Product Change Notice (PCN)

Subject: Lokreel size correction for listed Renesas ISL78365ARZ-T7A product

Publication Date: 9/26/2018

Appendix A – Lokreel comparison (Existing vs New)

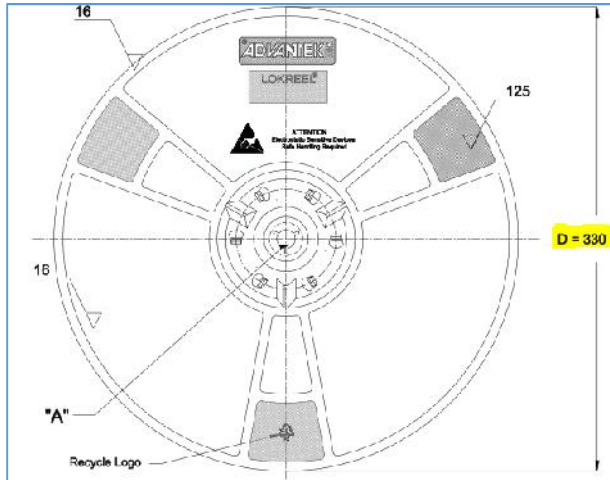
Lokreel reel size has been corrected from 13" to 7" for Renesas ISL78365ARZ-T7A tape and reel packing. There is no change to the standard pack quantity, i.e. 250 units per reel. The associated carrier tape and cover tape material as well as pocket design and dimension shall maintain per established manufacturing design.

This is a correction to the lokreel reel size only. The default ISL78365ARZ-T7A packing using 13" lokreel was in error and has been updated to use correct 7" lockreel.
